SPRUCE RESERVOIR

NDI I.D. PA-00587

PHASE I INSPECTION REPORT  
NATIONAL DAM INSPECTION PROGRAM

D'APOLONIA CONSULTING ENGINEERS  
10 DUFF ROAD  
PITTSBURGH, PA. 15235

PLATE 8  
 SPRUCE RESERVOIR  
 GENERAL PLAN  
 FIELD INSPECTION NOTES  
 FIELD INSPECTION DATE: APR 28, 1980

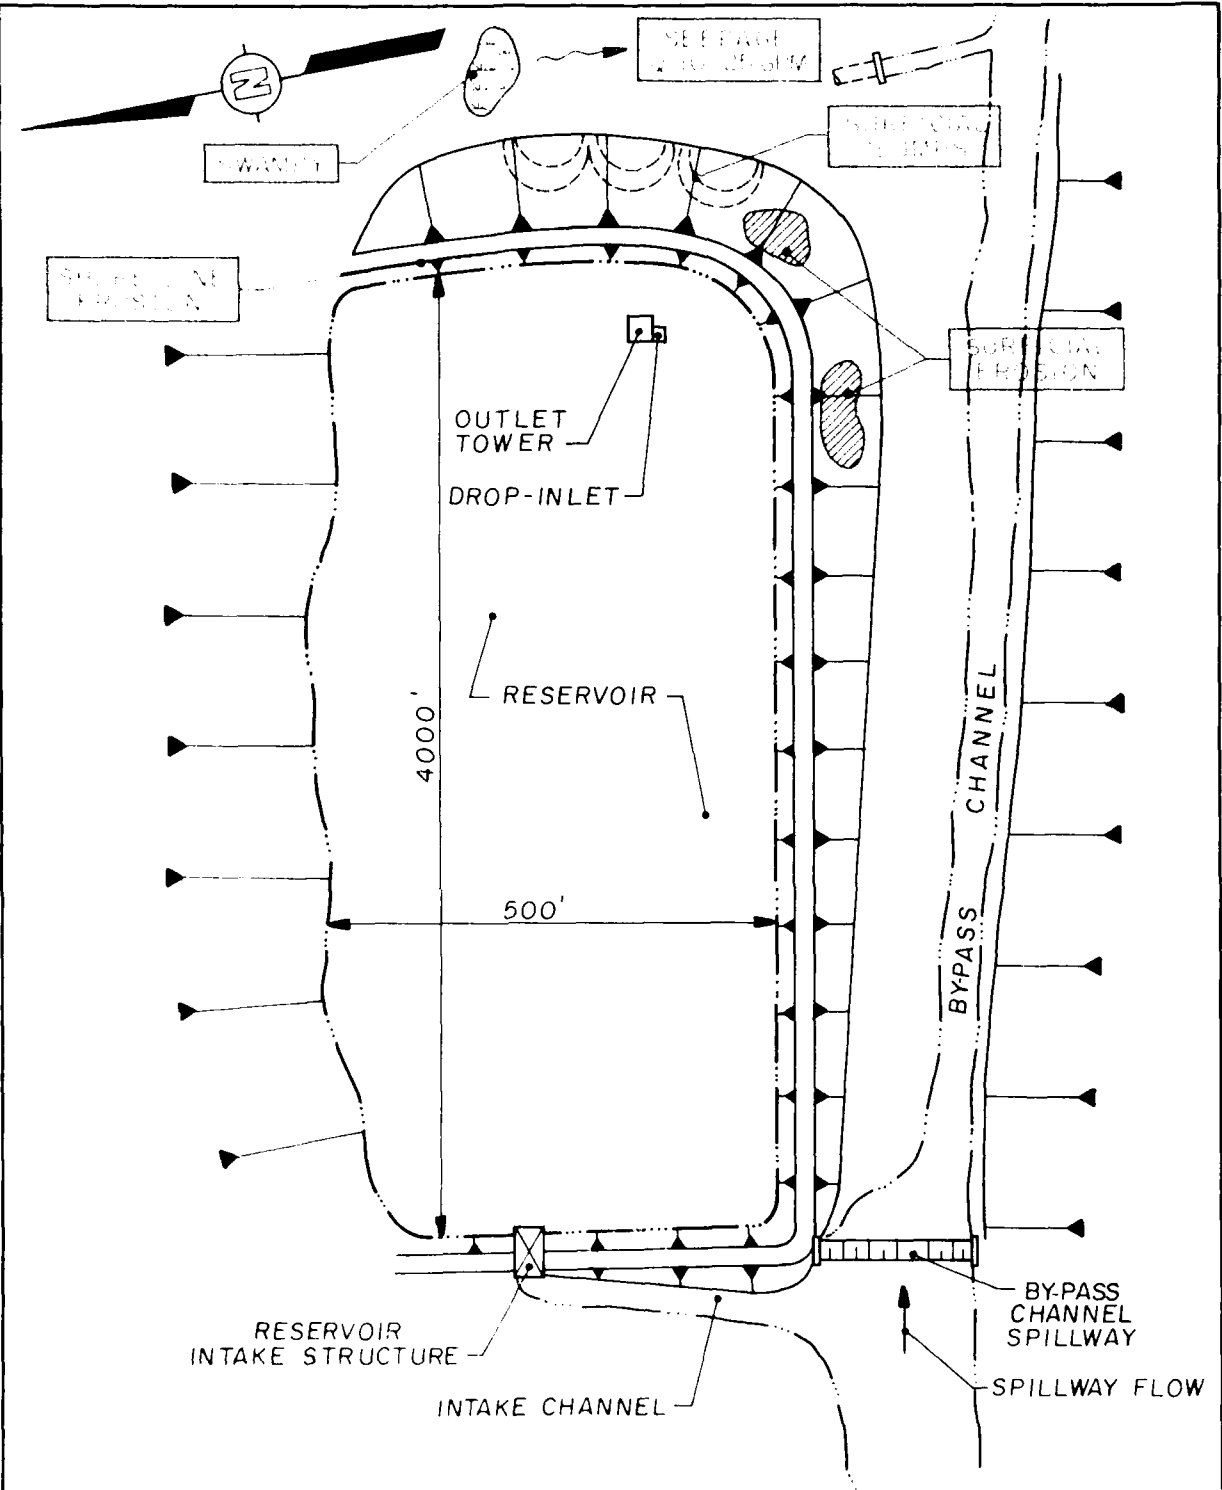
Plate 8 illustrates some of the existing features of the dam.

The embankment was found to be in fair condition. The conditions noted which require further attention are the indications of surficial slumps along the lower half of the main embankment at the downstream end of the reservoir. It appears that these conditions are caused by saturation of the poorly draining embankment surface material on a relatively steep (2H:1V) slope of the embankment. Although it is possible that a high phreatic surface through the embankment could be contributing to this condition, no noticeable seeps were found on the downstream slope of the dam that would support this observation. At this time, indications of surficial slumps are not considered to be serious relative to the overall stability of the embankment. Another condition noted was the presence of erosion in the areas where the embankment is lacking adequate vegetative cover. At the upstream side of the main embankment at its junction with the left abutment, riprap appears to have dislocated due to wave action, posing a potential for shoreline erosion. A swampy area was found at the toe level of the main embankment-left abutment junction with an associated seepage on the order of 10 to 20 gallons per minute. It was noted by the owner that swampy conditions have existed in the past and a french drain system was installed at the junction of the embankment and abutment to collect the seepage. This appears to be contributing to the swampy conditions along the toe of the dam. The present extent of the swampy condition is not considered to be serious relative to the overall stability of the dam.

The crest of the dam was surveyed relative to the bypass channel spillway crest level and the crest of the embankment along the upstream side of the reservoir was found to be up to 0.9 foot below the design crest elevation. The lowest point occurred adjacent to the bypass channel left abutment wall. The crest levels of the embankment along the bypass channel and the embankment on the downstream side of the reservoir were found to be essentially at or above the design level. The dam crest profile is illustrated in Plate 9. The downstream slopes were surveyed and found to be reasonably within the design slope of 2H to 1V.

1. POOL LEVEL DATE OF INSPECTION:  
23 FT BELOW DROP INLET CREST EL  
(DROP INLET CREST EL - BYPASS  
CHANNEL SPILLWAY CREST)
